Subject: **Permit Addendum for Section 404 Nationwide Permits 14 & 33 and Section 401 Water Quality Certification and Neuse Buffer Certification** for US 1/64 From US 64/SR 1009 (Tryon Road) Interchange to South of I-40 in Cary, Wake County; TIP No. U-3101C & D; State Project No. 8.1403101; Federal Aid Project No. STPNHF-1(4); USACE Action ID Nos. 200120922 & 200421562; NCDENR-DWQ Project No. 041055; WBS Element 34897.1.1.

The North Carolina Department of Transportation (NCDOT) – Division 5 has recently completed a pre-let environmental review associated with the widening of US 1/64 from US 64/SR 1009 (Tryon Road) Interchange to south of I-40 in Cary, Wake County. The pre-let review was based on the final roadway construction plan sheets and permit drawings that were attached to the permit applications dated June 18, 2004 and August 31, 2004.

The review identified all permit drawing and plan sheet discrepancies, as well as other associated constructability concerns that could be identified during the pre-let phase of this project. This Permit Addendum addresses the identified discrepancies and provides the

PROJECT REFERENCE NO. U-310IC&D	SHEET NO. 2-TT
R/W SHEET NO.	
ROADWAY DESIGN ENGINEER	HYDRAULICS ENGINEER
CONST. REV. 2-25-05	
R/W REV.

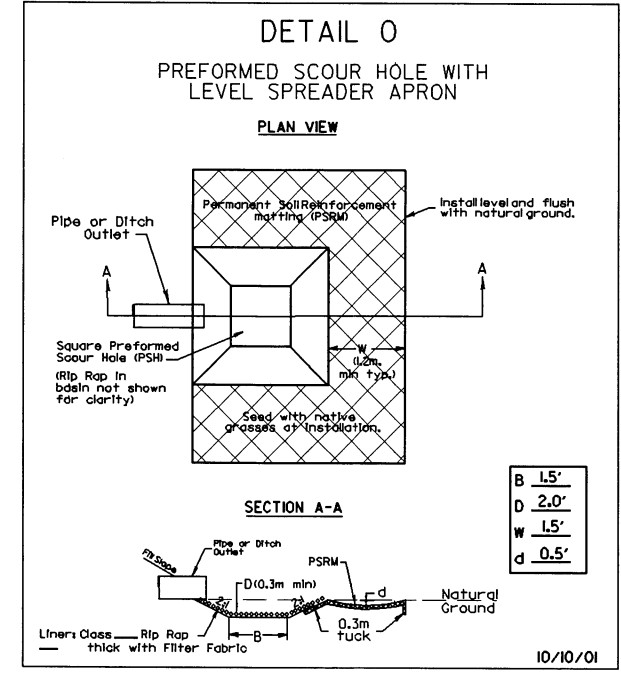
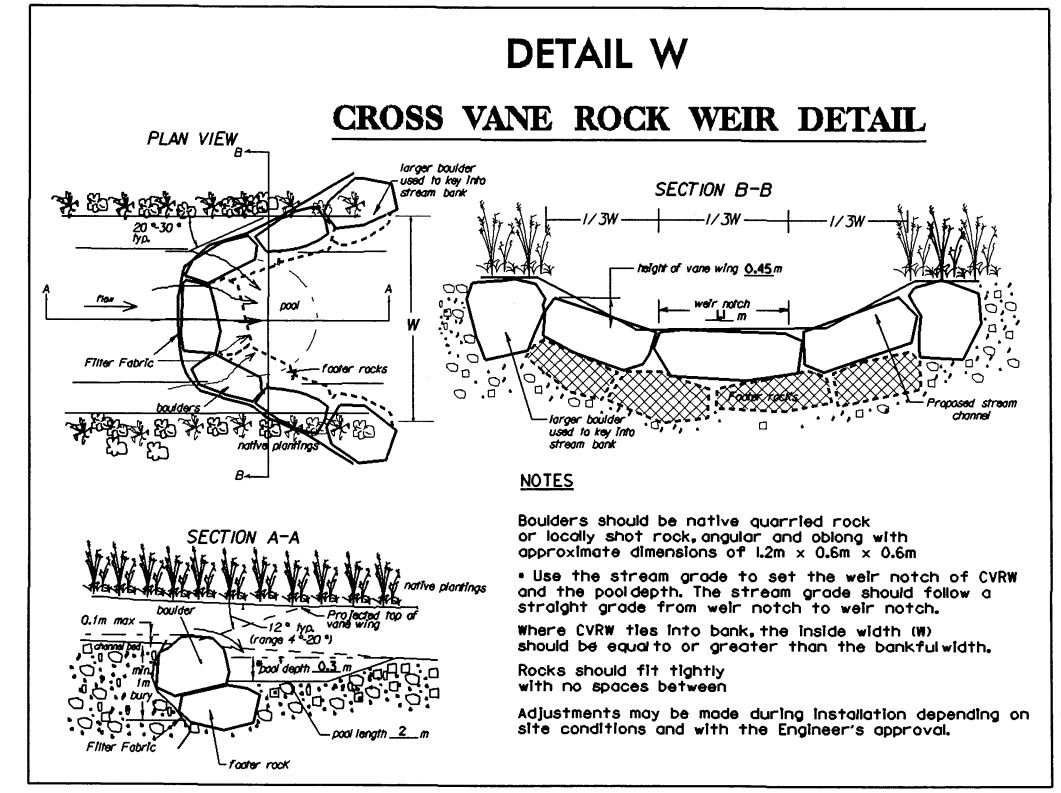
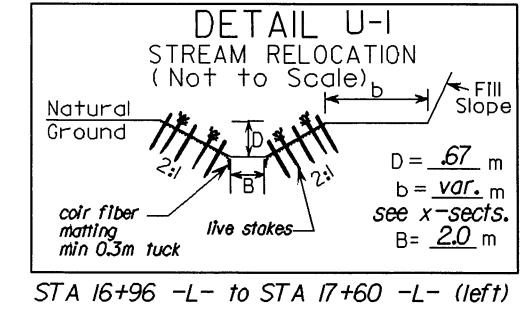
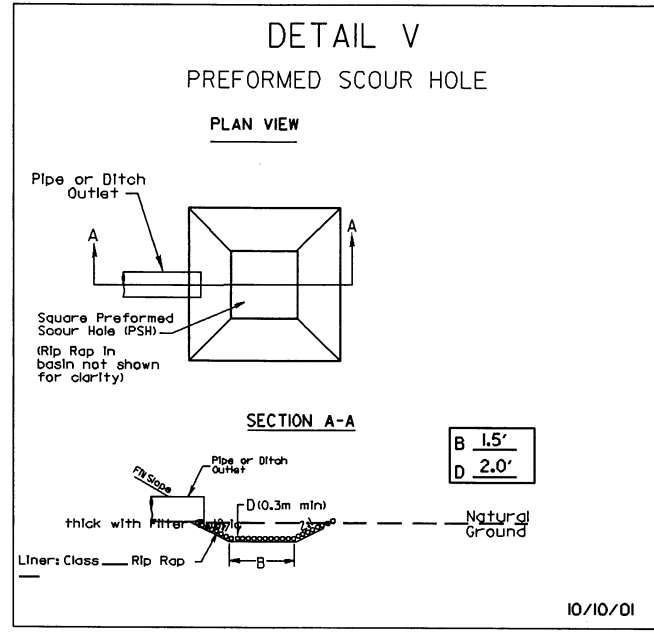
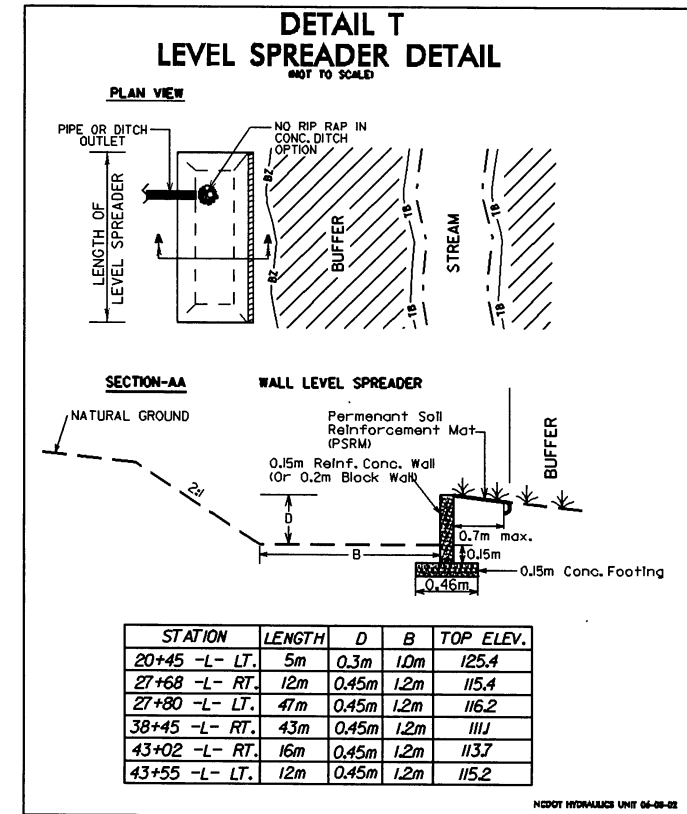
1. Delete Plan Sheet No. 2-F (Site One Stream Relocation) from the permit and replace with Plan Sheet No. 2-TT (dated 25-FEB-2005). This action will allow for depiction of the correct Station numbers on Detail U-1 [STA 16+96 -L- to STA 17+60 -L- (left)], will eliminate a second Detail U-1 and Detail U-2 that were incorrectly included on Plan Sheet No. 2-F, and will also allow for proper correlation of Detail W to Detail U-1.

STATIONS DELETED FROM "W" BY SRM 3-07-05
 STATIONS REVISED ON U-BY SRM 2-25-05
 07-MAR-2005 16:25
 C:\Users\miller\Documents\miller.dwg

PROJECT REFERENCE NO.	SHEET NO.
	U-310IC&D	2-UU
ROADWAY DESIGN ENGINEER		HYDRAULICS ENGINEER
CONST. REV. 2-25-05		
R/W REV.

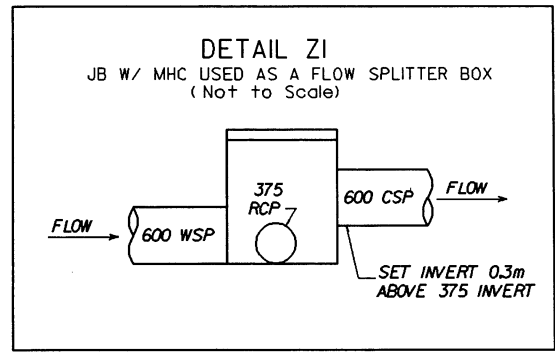
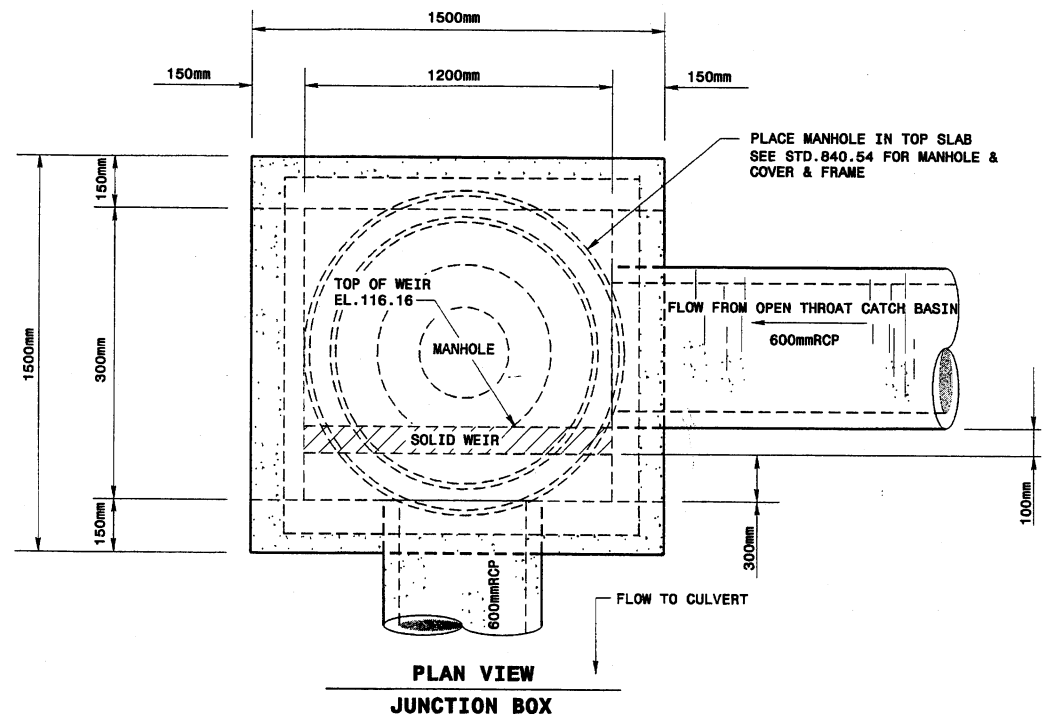
2. Delete second Plan Sheet No. 2-F (Site One Stream Relocation) from the permit and replace with Plan Sheet No. 2-UU (dated 25-FEB-2005). This action will allow for depiction of the correct Station numbers on Detail F [STA 17+60 -L- to STA 20+00 -L- (left)].

6. Replace permit drawing Sheet 18A of 21 with revised Sheet 18A of 21 (rev. 2-25-05). This action will allow for the inclusion of a reference for Detail J1 (installation of toe wall protection), which was not included on the original drawing. The addition of Detail J1 has been incorporated on to Plan Sheet 2-UU, which has already been noted to be included with the attachments (see Item No. 2).

25-FEB-2005 14:42
 R:\projects\110111\110111.dwg
 DETAIL J ADDED BY SRM 2-25-05
 25-FEB-2005 14:42
 R:\projects\110111\110111.dwg
